Thor Motor Coach Technical Service Bulletin

TSB #	TSB 26-06		
Description/Title:	DC/DC Charger setting		
Affected Product Line(s):	Certain model year 2026-2027 Eddie Bauer Van, Palladium, Sanctuary, Talavera, Tranquility		
Service Campaign # :	RC000343		
Codes:	Inspect Only: TMCTS80251U Inspect with Repair: TMCTS80251J	Document Date:	8/31/2026
Time Allowed:	Inspect Only: 0.1 Inspect with Repair: 0.1	Document Revision:	A

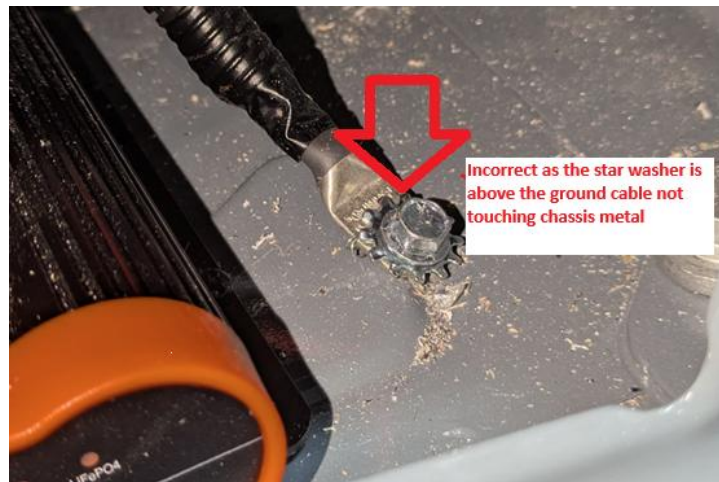
It has been discovered the DC/DC Charger may not have the correct (LiFePO4) type of house batteries selected. Constant exposure to improper charging will result in incomplete charging and/or premature battery aging.

1. Locate the DC/DC Charger under the passenger seat using the access door on the side of the pedestal.

2. Ensure the MODE setting is on LiFePO₄.

As a precautionary measure, ensure the grounding cable & stud under the passenger cockpit chair is secure and tight with the star washer touching the chassis metal and not on top of the ground cable with no contact to chassis metal.
